P430QVN01.0 MA Factory M02->S13 EC

Product Specification

P43 Series Design Change

- Description: Design Change Items for P43QVN01.0 (97D43P03.003)

P430QVN01.0 SPEC update

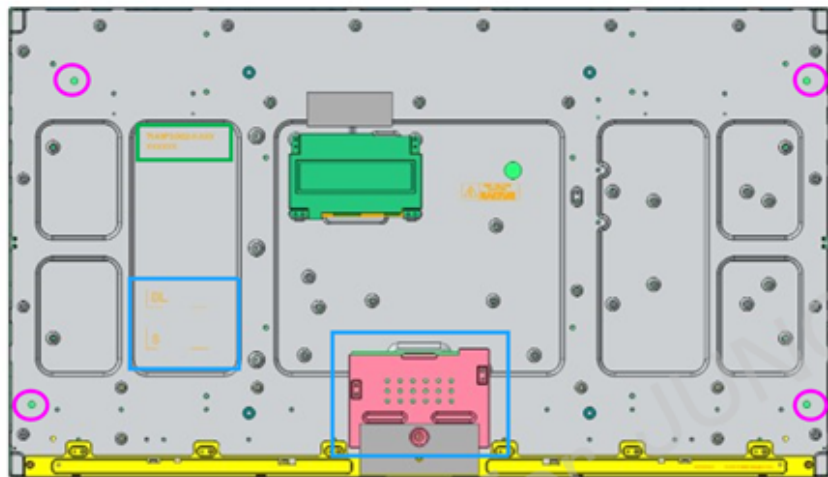
Parameter↵	Symbol↵	Value↵			Unit↵	Note↵
		Min.↵	Typ.↵	Max↵		
LCD↵	↵	↵	↵	↵	↵	↵
Power Supply Input Voltage↵	V _{DD} ↵	10.8↵	12↵	13.2↵	V _{DC} ↵	↵
Power Supply Input Current ↵	I _{DD} ↵	--↵	0.85↵	1.9↵	A↵	1↵
Power Consumption ↵	P _C ↵	--↵	10.2↵	22.8↵	Watt↵	1↵
Inrush Current ↵	I _{RUSH} ↵	--↵	--↵	5↵	A↵	2↵

Item		Symbol	Min.	Typ.	Max	Unit	Note
Power Supply Input Voltage		V _{DD}	10.8	12	13.2	V	1
Power Supply Input Current	Black pattern	I _{DD}	-	0.73	0.88	A	2
	White pattern		-	0.75	0.9	A	
	H-strip pattern		-	1.42	1.71	A	
Power Consumption	Black pattern	P _C	-	8.76	10.56	Watt	
	White pattern		-	9	10.8	Watt	
	H-strip pattern		-	17.04	20.52	Watt	
Inrush Current		I _{RUSH}	--	--	5	A	3

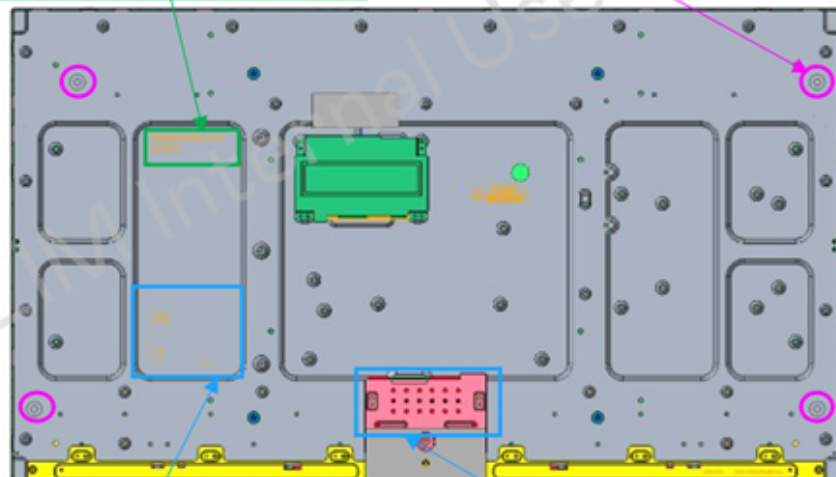
Part Number update.

Hole Change

The label position moved down 20 mm.

T-con & cover resize

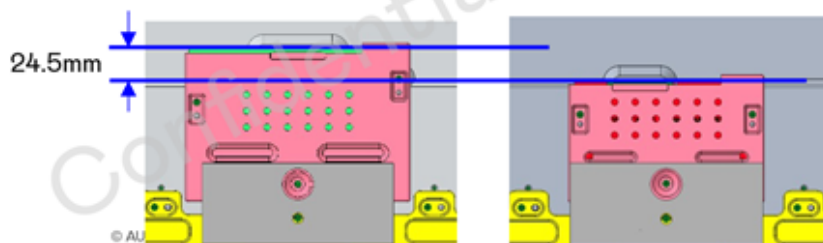
T-con & Cover Dimension Change Description:

- T-con size change: from 160 mm × 80 mm to 133 mm × 57 mm
- CNT T-con cover moved down: 24.5 mm
- T-con cover width reduced: by 23 mm
